**CICADA  
ENGINEERING  
SPECIFICATION**

DOCUMENT NO.  
TFTR-10B4-H404A

Timing Module Type 404

SUBJECT : H404A Timing  
Modules

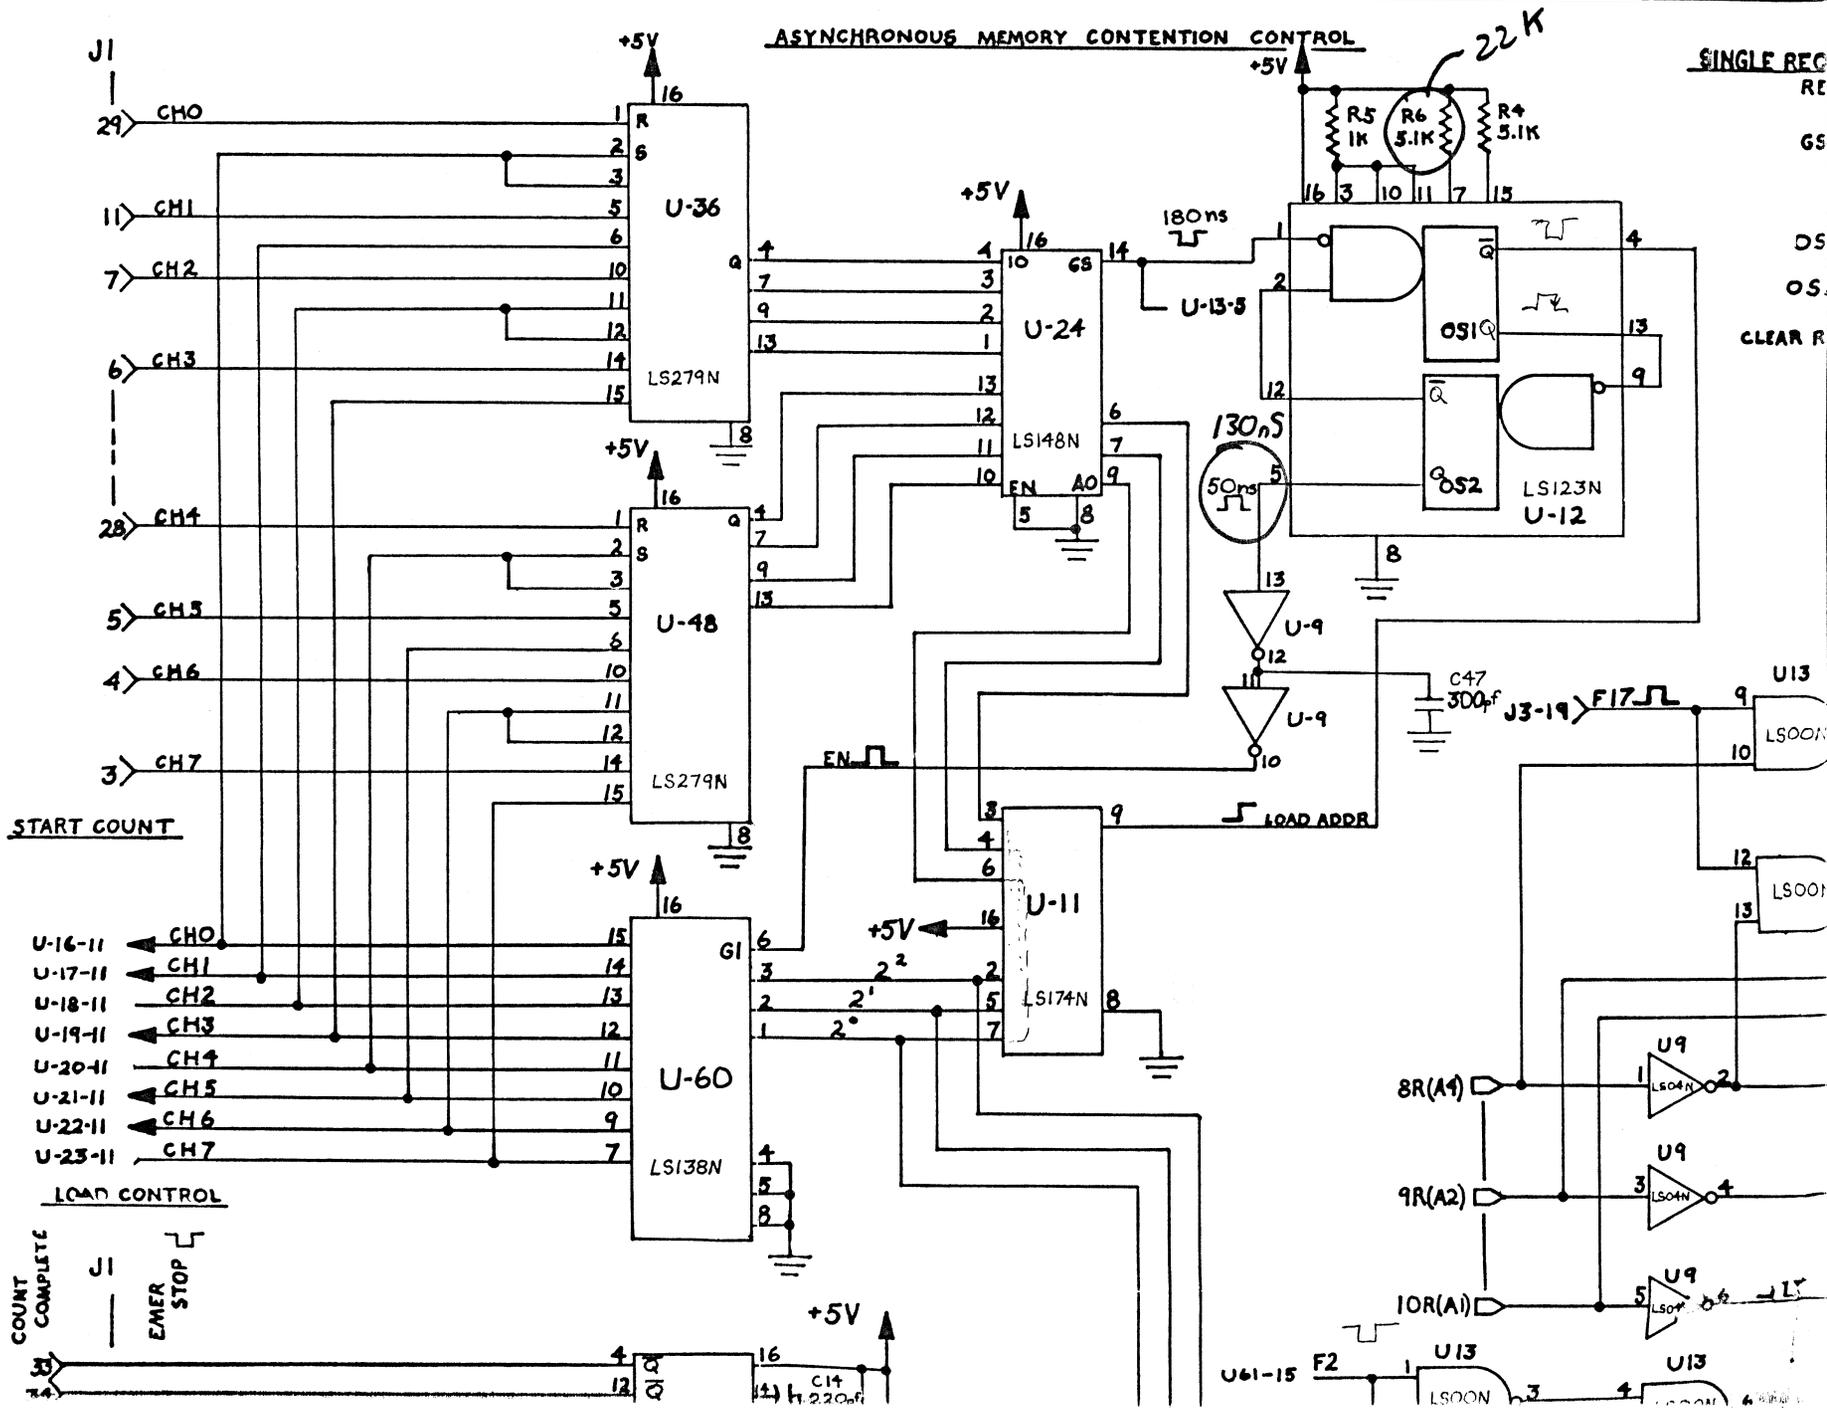
Recently, another problem with the CAMAC H404A Timing Module has been discovered. The problem will be referred to as the 'CH8' problem. The effect of the problem is an extended timing delay for channel eight of the timing module. This problem occurs only when all of the following events transpire :

- 1) Channel 8 has responded to a TFTR Facility Clock event code, and is counting down.
- 2) While CH8 is counting down, another of the timing module's channels (CH1-CH7) responds to a TFTR clock event code and loads its delay counter.

When (1) and (2) happen, CH8's delay counters are inadvertently reloaded. The reloading of CH8's delay counters is due to an extraneous pulse in the H404A circuitry. The pulse is due to a race condition in the logic design.

A solution to this problem is to alter the timing of the appropriate circuitry on the H404A module. The alteration will extend the duration of a pulse generated by IC12-5 on Board A. The pulse is extended from 50 ns to 100 ns by changing R6 from 5.1 Kohms to 22 Kohms. This change will slow down the scan-and-load process for the timing module. At worst case, when all eight channels recognize the same event code, CH1 and CH8 can be skewed by an additional 1 microsecond. I estimate that the module upgrade will expend two technician hours. (retrieve, upgrade, test, install).

I recommend that all timing modules in the field be upgraded to incorporate the R6 change. I would like to see the following transpire :

Picture 1

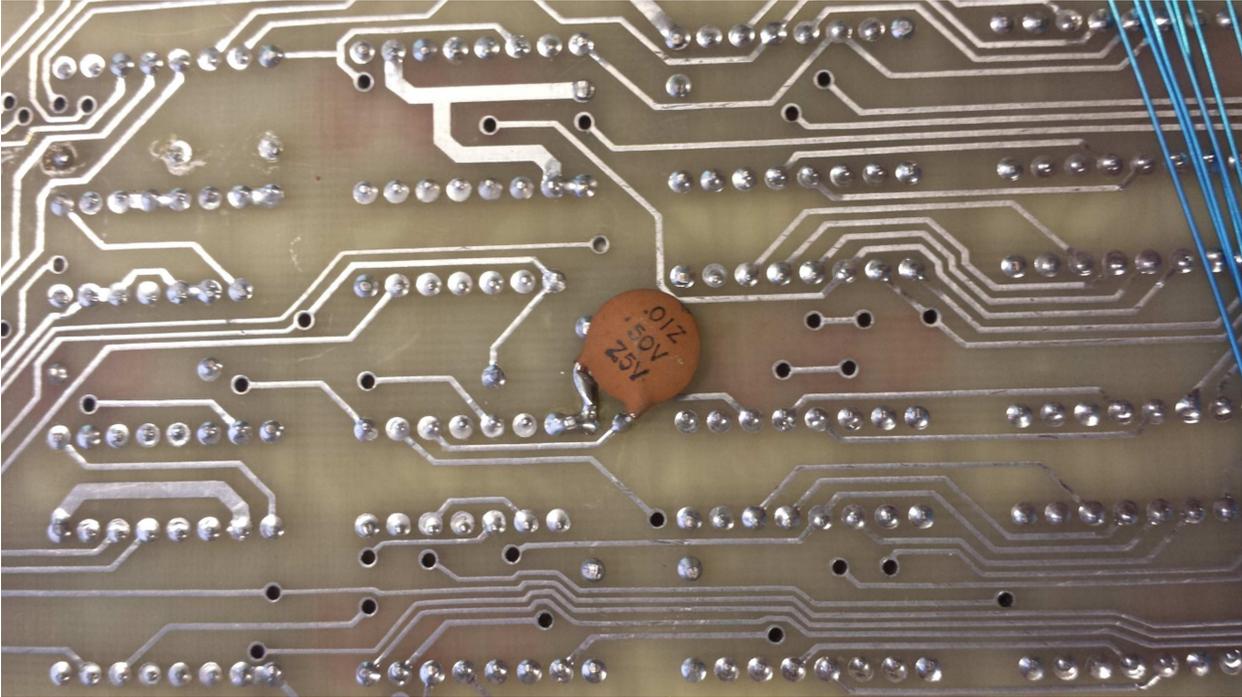
U29 0.01uf capacitor pin 3 to ground on B board (solder side, see picture 1)

Picture 2

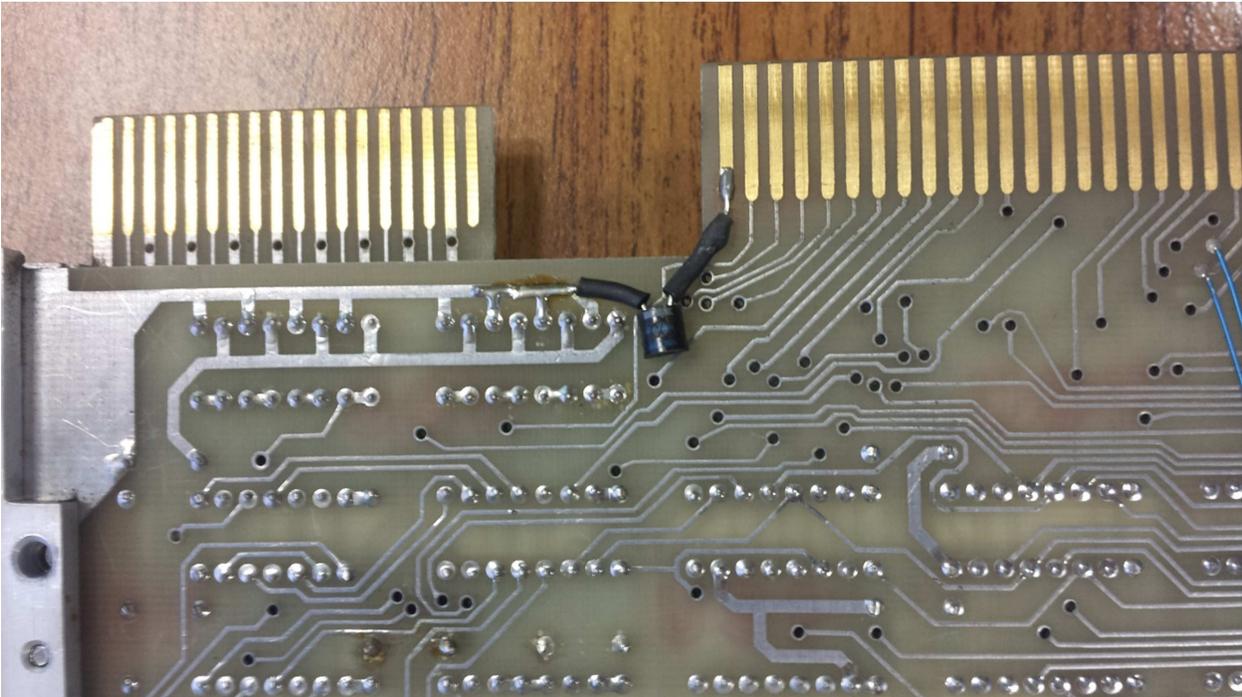
Schottky diode (Motrola MBD501) from dataway pin 1R (BUSY) to ground on B board. (Anode goes to ground) (See Picture 2)

## PROPER TIMING OF 404A R6 BOARD A (LEFT)

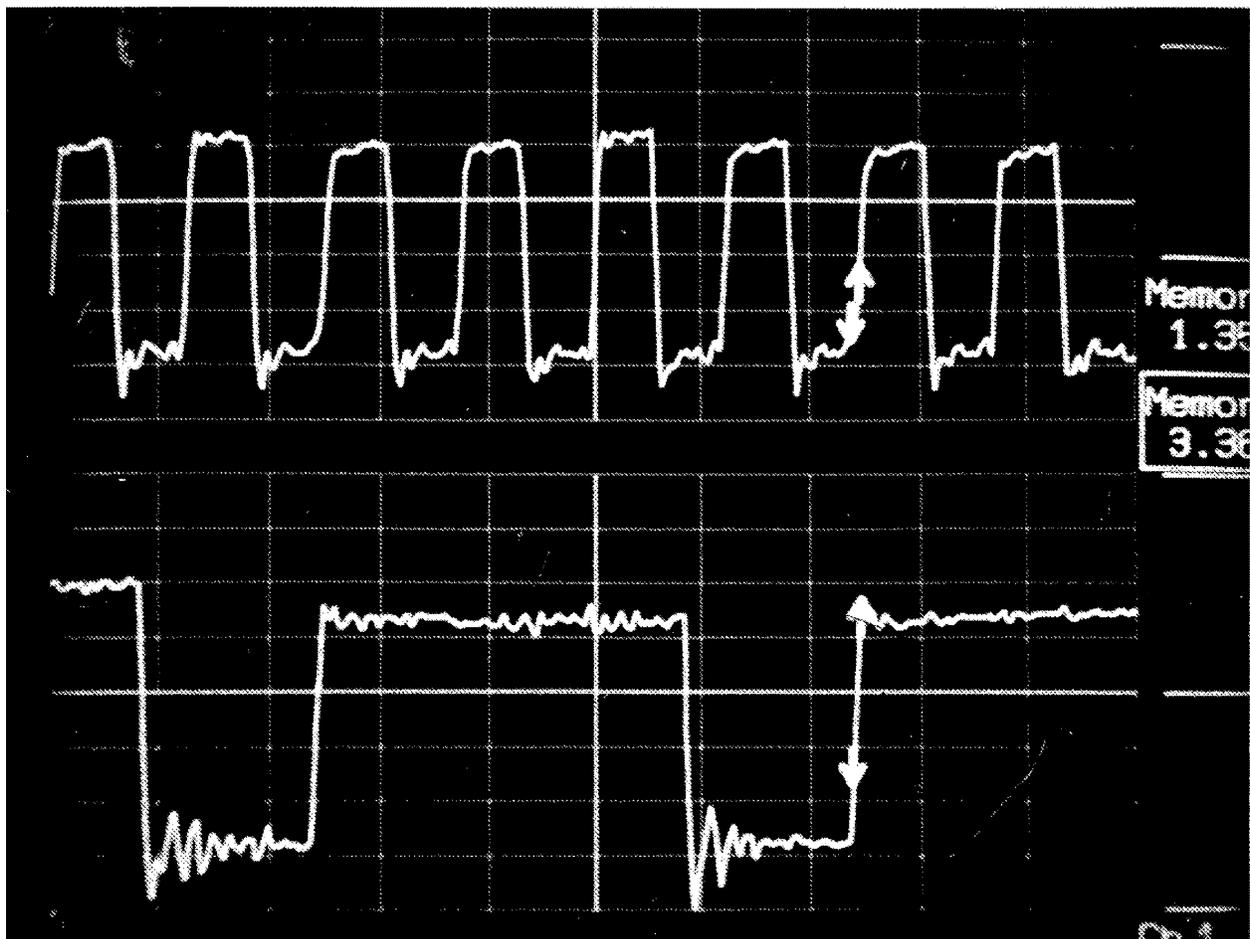
Top trace=U60 pin 6 (Enable for 74LS193 load input, going through 74LS138)

Bot trace=U64 pin 5 (74LS193 Clock input)

The bottom trace is not allowed to go through any transition unless the top trace is low. The rising edge of the bottom trace may line up with the rising edge of the top trace, but must not happen immediately before it. Top trace=4Mhz, 8 pulses. This timing can be adjusted by changing the value of R6 on the "A" board. It is always best to start with 22K, then adjust as necessary. It is OK to use 1% precision resistors to fine tune this timing if 5% resistors don't achieve the proper timing. 1% resistors come in more standard values than 5% resistors, so it is more likely to find just the right value that works.
